GTM965500P

Test Report

54V Model

GlobTek Engineering

54V	Voltage Ripple	CLOSED	OK / Resolved

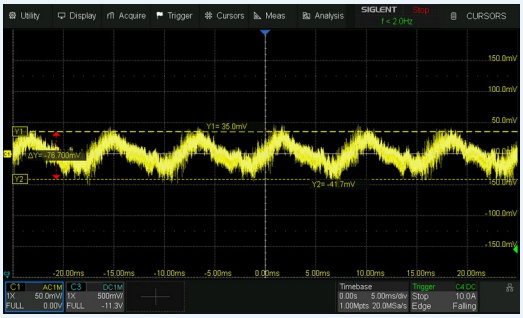
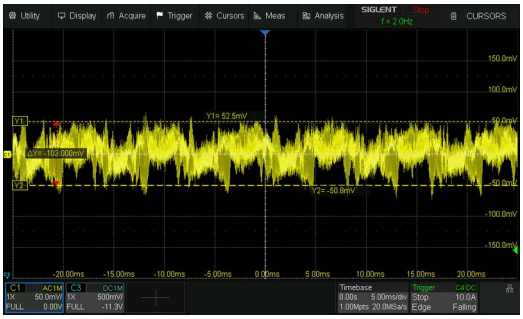
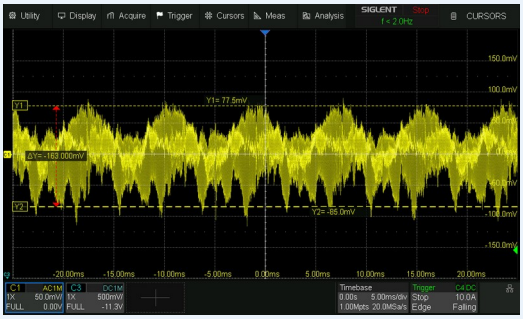
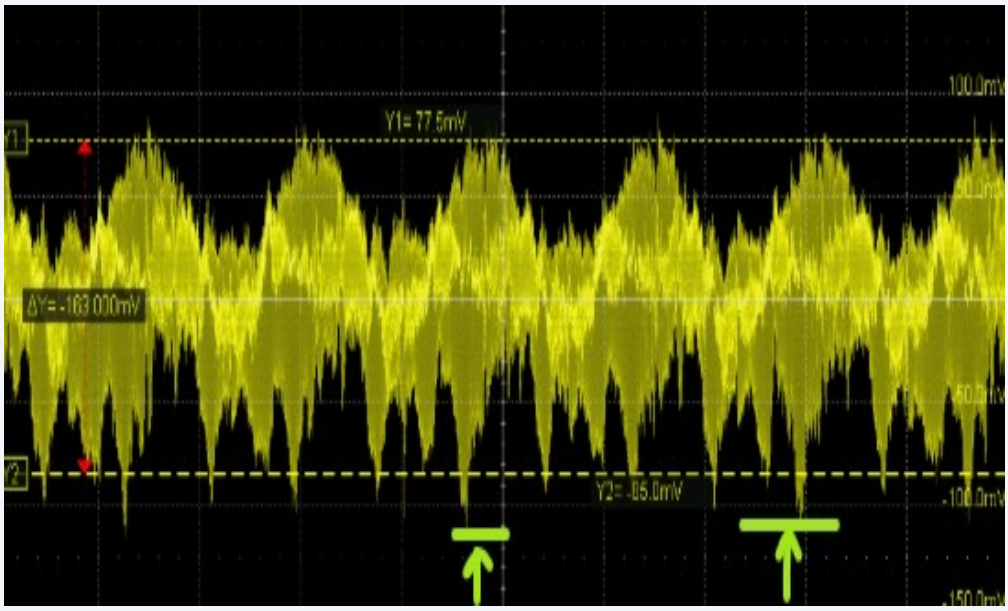
Good. For the future, I would include all spurious parts of the waveform as part determining the ripple. I know 95% of the waveform falls within the bounds you show, but it's still a bit subjective.

We are very far away from the limit here so it's not really an issue.

54V	Hold-Up Time	OPEN	Marked for review

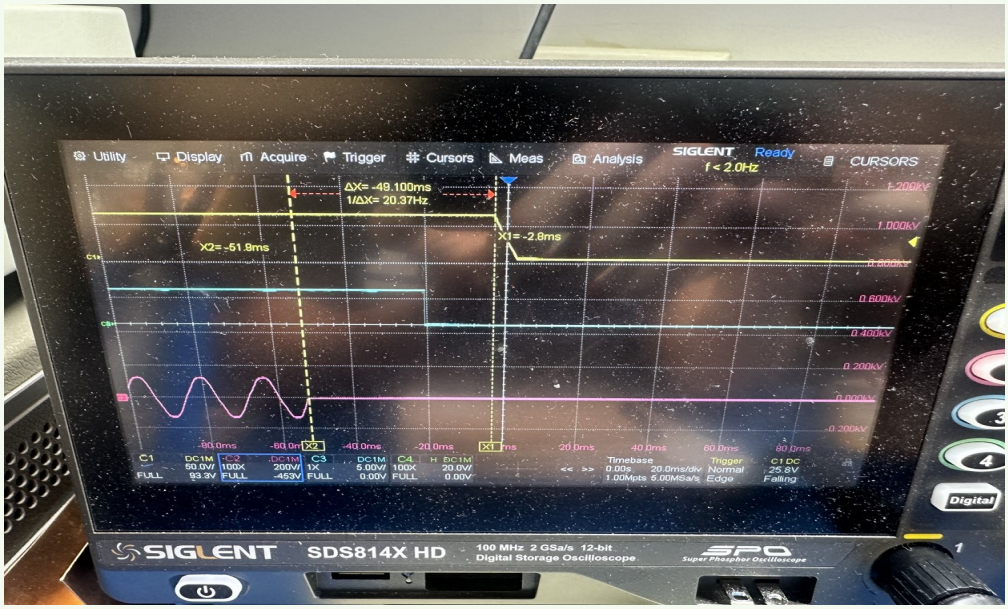
@ max output voltage @ 50% load, the Hold Up time is a little bit slow. but maybe we don't care....
